From: [Navecky, David](#)
To: CZorbaugh@bakerandmiller.com
Subject: AB 183 (Sub-No. 5X) - Verification of the MCR Track
Date: Tuesday, May 11, 2021 9:48:00 AM
Attachments: [Tentative Map of MCR Track.pdf](#)

Tentative Map of the "MCR Track"
AB 183 (Sub-No. 5X)

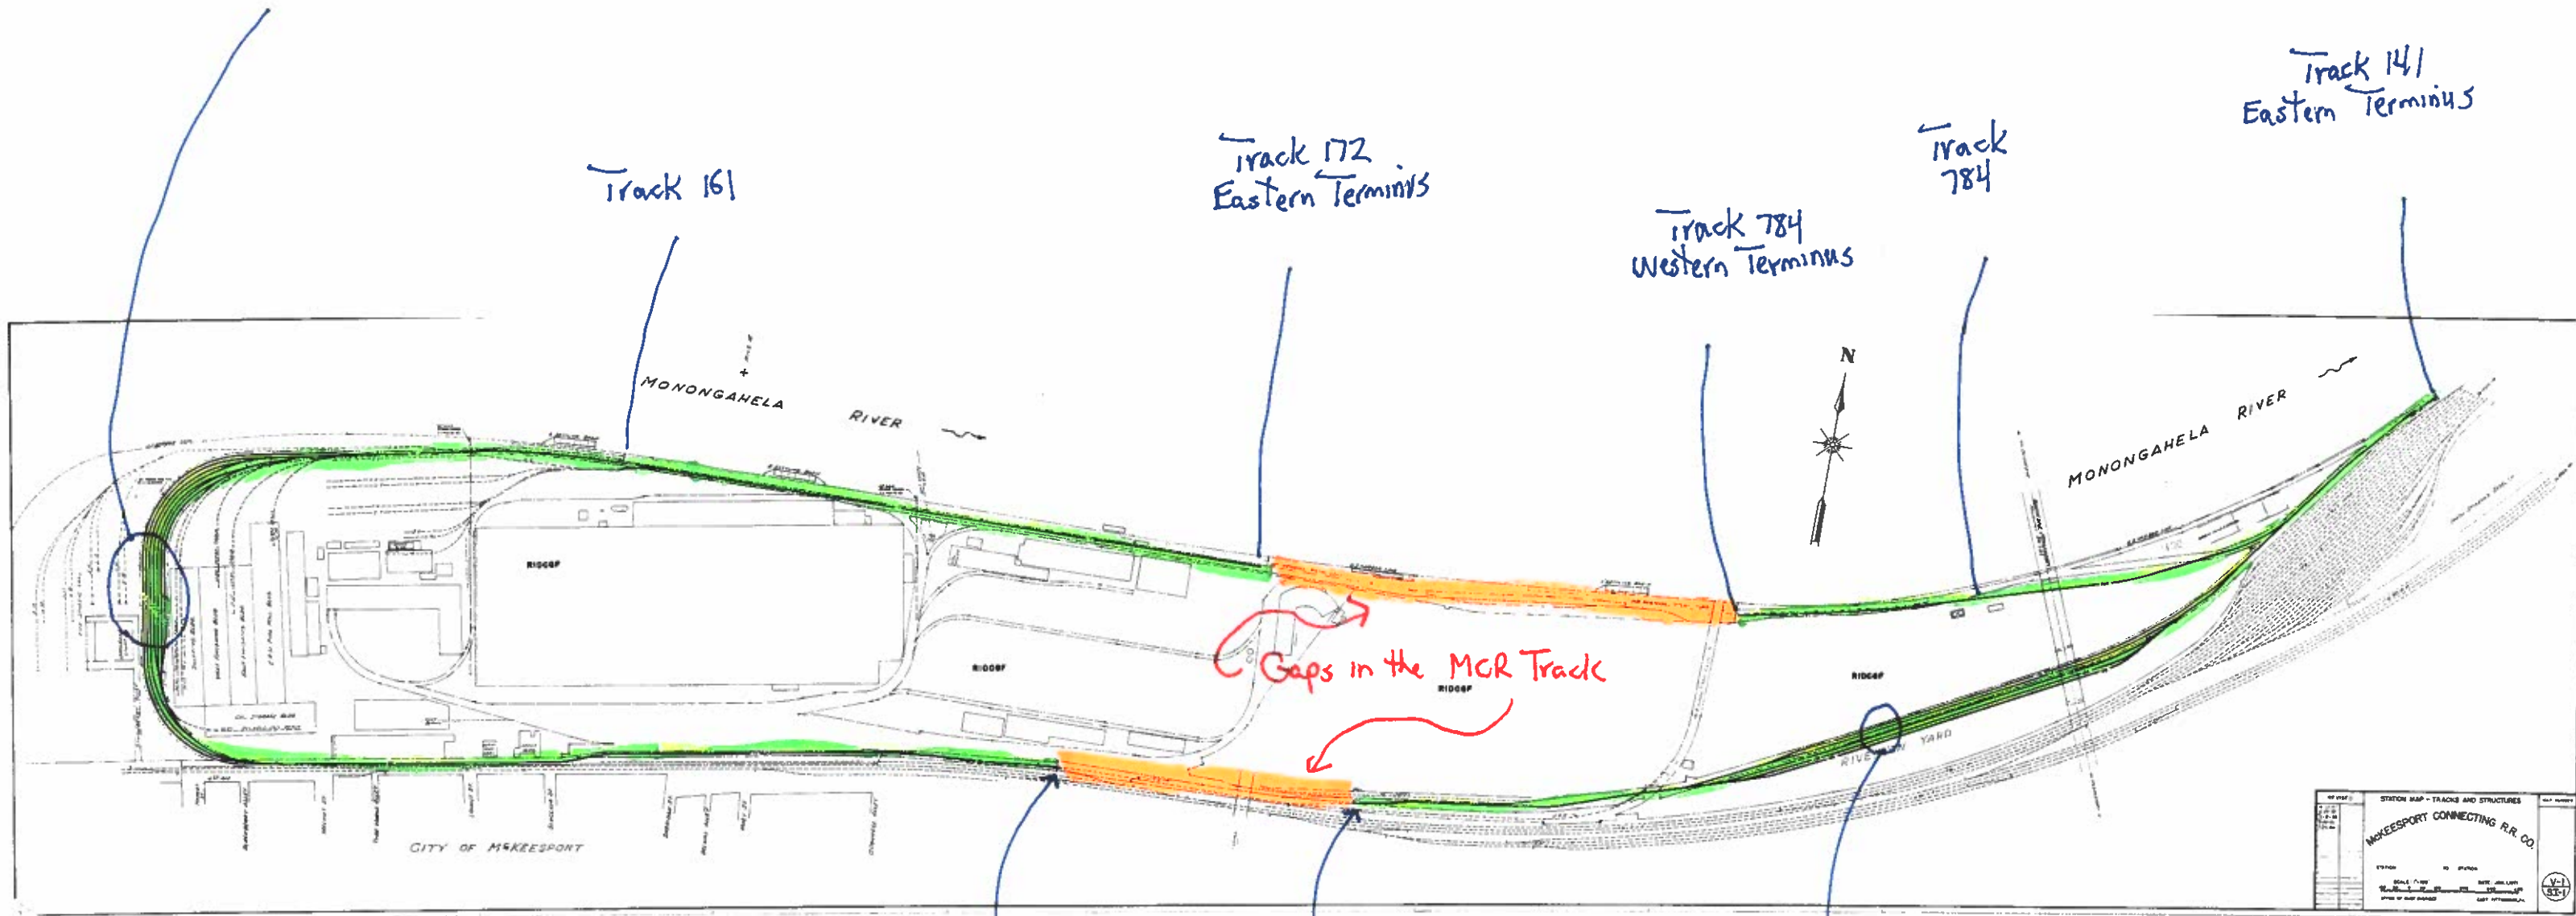
Thank you for the figures that you sent yesterday. It appears that the figure titled “MKCRR-Tracks & Structures-V-1_ST-01-McKeesport” may be the most informative of the material provided for the purposes of identifying what the “MCR Track” consists of. If you could please verify the following statements, while referencing the attached marked-up version of that figure (because of the poor resolution of my scanned copy, you may need to refer to the original figure as well, particularly to delineate track numbers):

- The MCR Track is represented by the bolded black lines on the figure, which I have further highlighted in green.
- In greater detail, the MCR Track includes the following single and multiple track segments (in ascending numerical order): Tracks 98, 132, 138 through 142, 161 through 167, 172, and 784.
- The MCR Track does NOT include the two gaps (where no bolded black lines are present, and further highlighted in yellow) between the eastern terminus of Track 172 and the western terminus of Track 784, and the eastern terminus of Track 98 and western terminus of Track 132.
- If the MCR Track does exist in the two “gaps” noted above, please confirm that these gap segments are single tracked.
